RE: SUBMISSION LETTER TO STATE SIGNIFICANT DEVELOPMENT APPLICATION | 93 BRIDGE ROAD, WESTMEAD

This submission letter has been prepared by Paro Consulting on behalf of the Community Association DP 220360, Monarco Estate, (the association representing individual Strata Plans SP70764, SP73889, SP74611 and SP77983). The submission letter is in relation to a State Significant Development Application (SSD) application submitted to the Department of Planning, Housing and Infrastructure (Major projects ref. SSD 80904224) for a large-scale residential development comprising 549 dwellings, across two residential towers, basement carparking, landscaping and public domain works.

Figure 4. Proposed Section demonstrating anticipated building height (SSD submission)

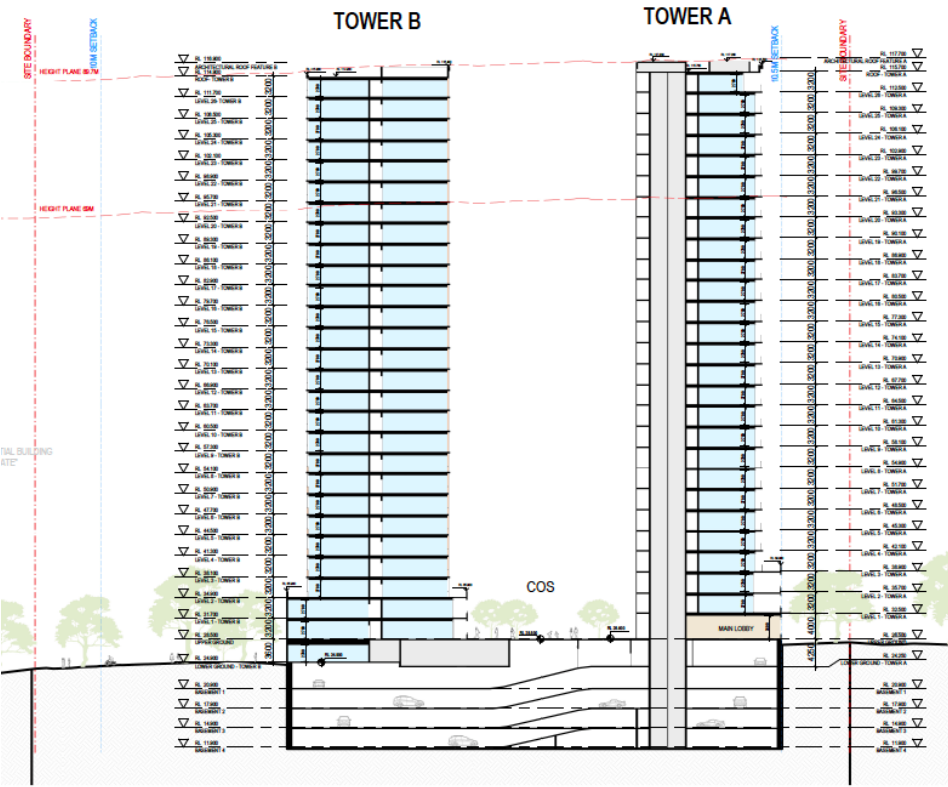
The proposal includes two residential towers presenting a 27-storey (maximum) development with a maximum building height of 89.7m as shown below in Figure 4. The proposed maximum building height is excessive in nature when considered against the current planning controls and the surrounding built context and is considered to present a development that is highly inconsistent with the character of the area. As shown in the figures below, the site is located at the centre of an established residential neighbourhood which exhibits a generally residential character and is predominantly defined by; low scale residential flat buildings of 3 – 4 storeys, Government owned key worker housing consisting of 2 – 4 storey building blocks and multi storey apartment building up to a height of 15 storeys (Figure 5). Further, we note that the Parramatta LEP 2023 Height of Buildings Map depicts a maximum building height of 20m to the subject site, with the permissible building height increasing to 30 - 40m surrounding the Westmead Station to the east and 30 - 62m surrounding the Wentworthville Station to the west (Figure 6). Generally, the preferred building height immediately surrounding the development site ranges from 9m to a maximum of 20m.

Considering the context of the site, two residential towers of approximately 89.7m is highly inconsistent with the character of the residential neighbourhood. The proposed height is disproportionate in relation to its surroundings; it undermines the established character of the locality and raises significant impact on existing residential development.

In our opinion, the proposed building height is not suitable at this site and should not be supported. We submit that the number of dwellings should be reduced to present a more appropriate building height

Figure 4 below depicts the proposed SSD height plane at 89.7m, the lower height plane relates to the 69m building height proposed under PP-2023-2810.

Figure 8. Proposed pedestrian access along SP77987 and DP220360

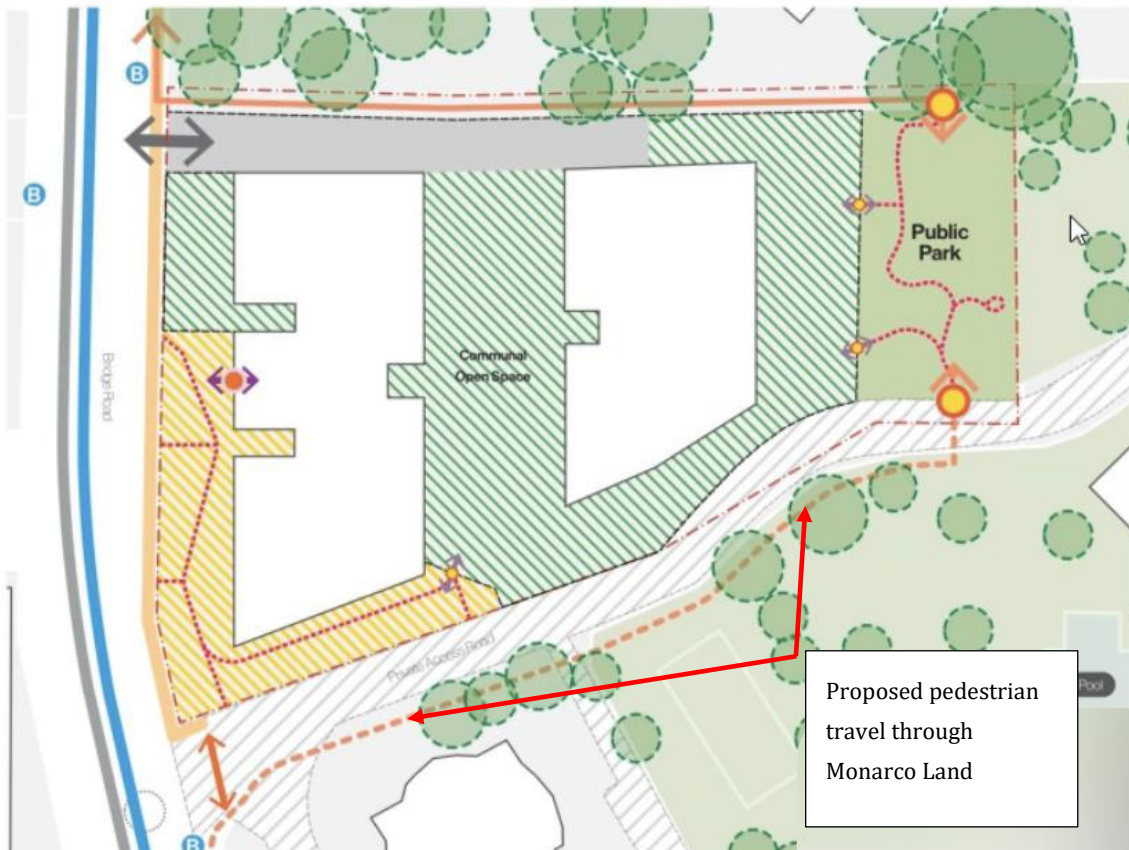
As shown in Figure 7 below, the proposal includes two publicly accessible pedestrian points of entry from the site's southern boundary, the first via a gate to the proposed communal open space which opens onto the private road and the second via an opening to the proposed

public park. The proposed openings within the fencing along the southern boundary will encourage a high level of public access through the Monarco land, including the use of the private road and footpath, resulting in trespass of approximately 200m, which should be avoided.

Figure 8 below demonstrates that the access to these openings would require users to walk along the road and the private footpath which is part of Block D, resulting in trespass.

The proposed exit from the public park on the south causes the most serious trespassing issue. The consultation report describes this park entry point as an 'emergency exit' only however, this has not been reflected in the EIS or the architectural drawings. We submit that any emergency exit should be via 93 Bridge Road and not reliant upon the use of private land within Monarco Estate. The proposed southerly fencing should extend from Bridge Road to the south east corner of the site where the property adjoins Block A of Monarco Estate to ensure an internal public footpath can be provided for safe and lawful access.

We submit that the proposed southerly fence separating the public and private spaces at 93 Bridge Road, should extend the full length of the site's southern boundary, with pedestrian access located to the west of the proposed kiosk / substation via Bridge Road and not the private road. This would ensure pedestrian access is provided wholly within the site of 93 Bridge Road and prevent the public and future residents accessing the private road and footpath within Monarco Estate.

Figure 9. Proposed pedestrian travel path, edited to demonstrate unauthorised access through 91A Bridge Road

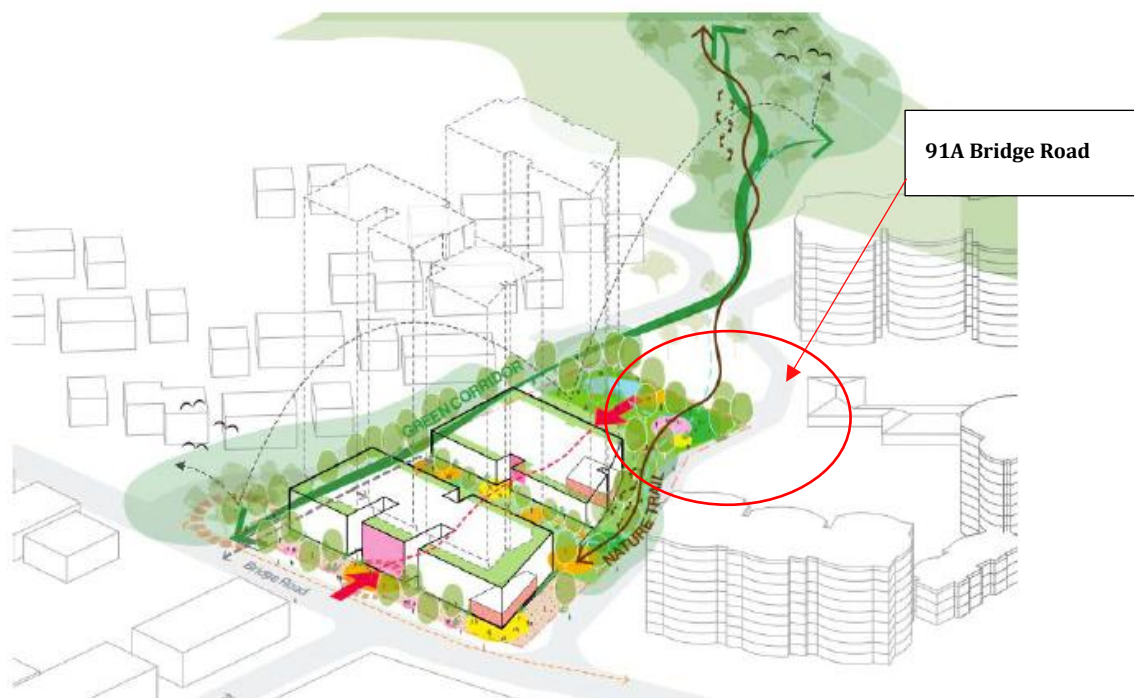
The proposal appears to include a publicly accessible path of travel, in the form of a nature trail, along the southern and northerly boundary of 93 Bridge Road, through the proposed park at the rear of the site and onto the boarder green open space network to the east and north east of the site and the defined north south active transport link as identified in the Westmead Place Based Transport Strategy and the Westmead Place Strategy (Figure 9). From a review of the submitted documentation and relevant mapping we note that this proposed pathway traverses through 91A Bridge Road with no formal easement in place and would result in unlawful access. It is also noted that the supporting Landscape Report incorrectly refers to the adjoining site as 'adjoining parkland' when it is in fact private land and consists of a stormwater basin which is flooded during rain.

The proposal presents a misleading design, access to the future reserve and future 'green grid,' cannot be achieved and the connectivity detailed in the EIS cannot be achieved as it appears to rely upon unauthorised access through private land at 91A Bridge Road.
